**City of Portland, Maine – Building or Use Permit Application** 389 Congress Street, 04101, Tel: (207) 874-8703, FAX: 874-8716

Location of Construction: 6 Hemlock St		Owner: Friedrich, Robert		Phone: 871-0240		Permit No: <b>971031</b>	
Owner Address: 28 Church St Gorham, ME 04038		Lessee/Buyer's Name:		Phone:		BusinessName:	
Contractor Name:		Address:		Phone:		<div style="border: 2px solid black; padding: 5px; text-align: center;"> <b>PERMIT ISSUED</b>                  SEP 24 1997  <b>CITY OF PORTLAND</b> </div>	
Past Use: 1-fam		Proposed Use: Same		COST OF WORK: \$ 500.00		PERMIT FEE: \$ 25.00	
Proposed Project Description:  Remove existing porch & stairs & doorway/Board-Up Erect Stairs - Different Location				FIRE DEPT. <input type="checkbox"/> Approved <input type="checkbox"/> Denied		INSPECTION: Use Group: <b>R3</b> Type: <b>SB</b> <i>000096</i>	
				PEDESTRIAN ACTIVITIES DISTRICT (P.A.D.) Action: <input type="checkbox"/> Approved <input type="checkbox"/> Approved with Conditions <input type="checkbox"/> Denied		Signature: _____ Date: _____

BUILDING PERMIT REPORT

**From:** Marge Schmuckal  
**To:** DSV  
**Subject:** curb cut requests for 77 Spruce St. and 6 Hemlock St.

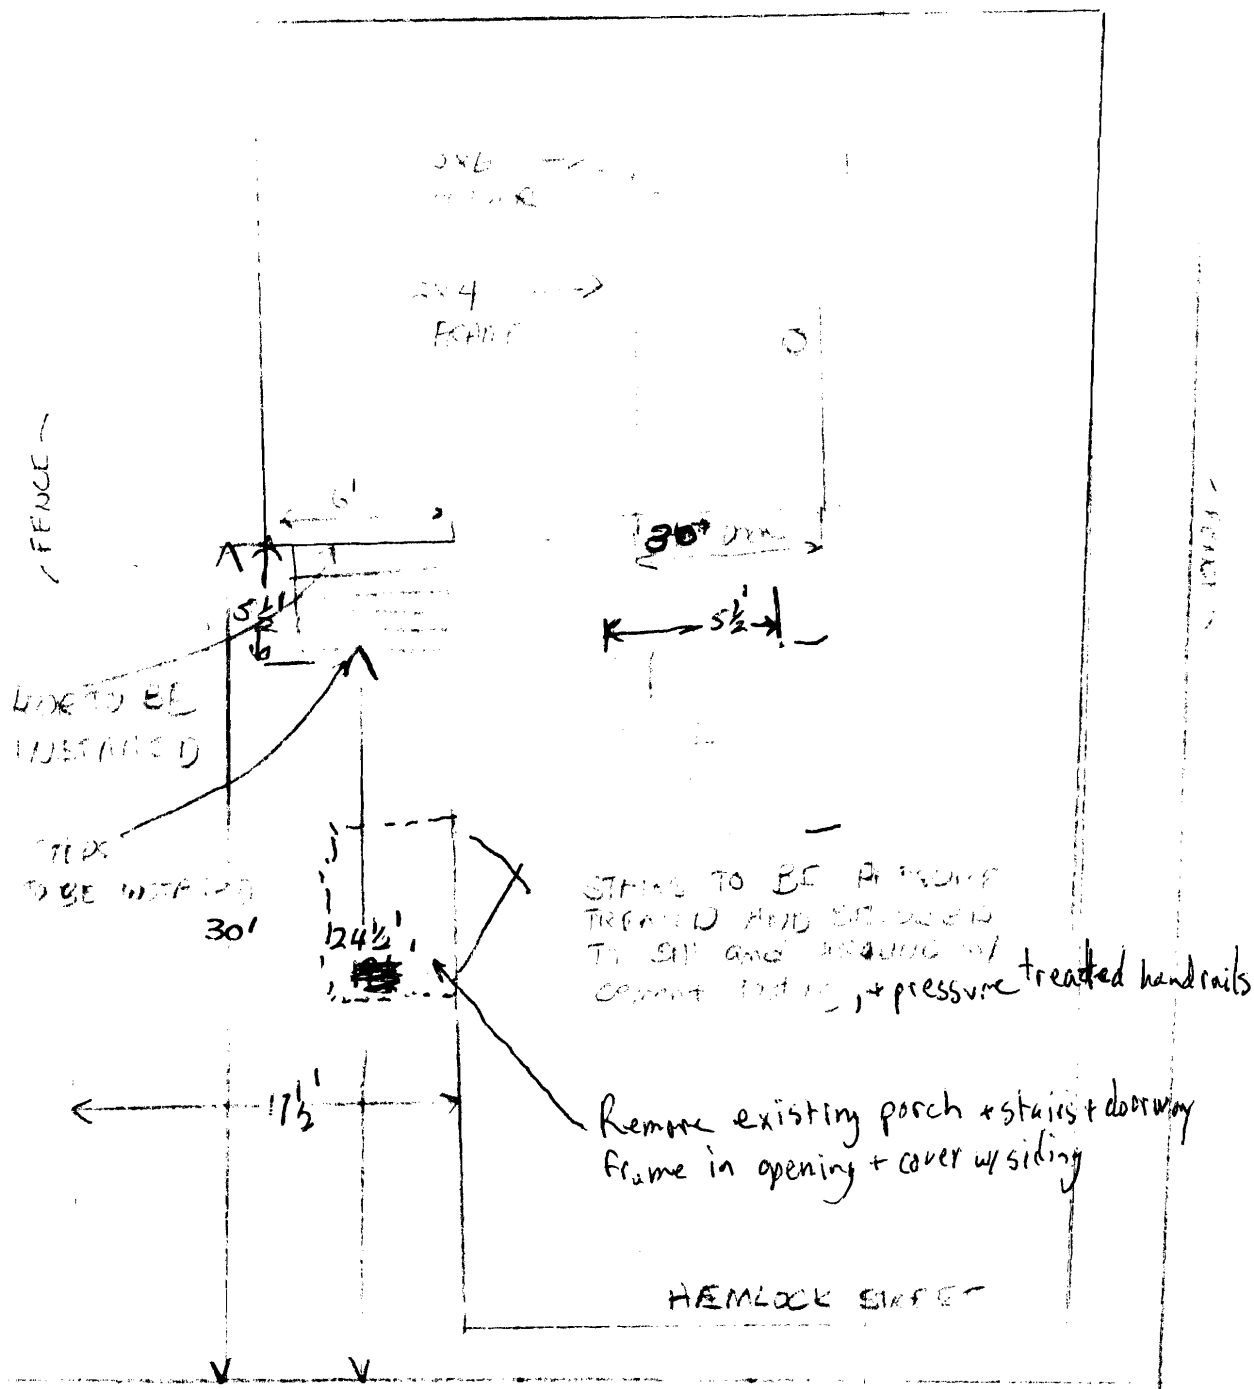
2) On 9/23/97 I re-inspected 6 Hemlock Street per request of the owner. He has recently removed a small addition in order to allow more room for potential parking. He told me that the wooden fence is the lot line. I measured 15 feet from the wooden fence to the building. That would allow for a 9'x19' parking space along with a 5 foot setback. I would now say that he could meet the land use ordinances as far as setbacks if you allowed a curb cut.
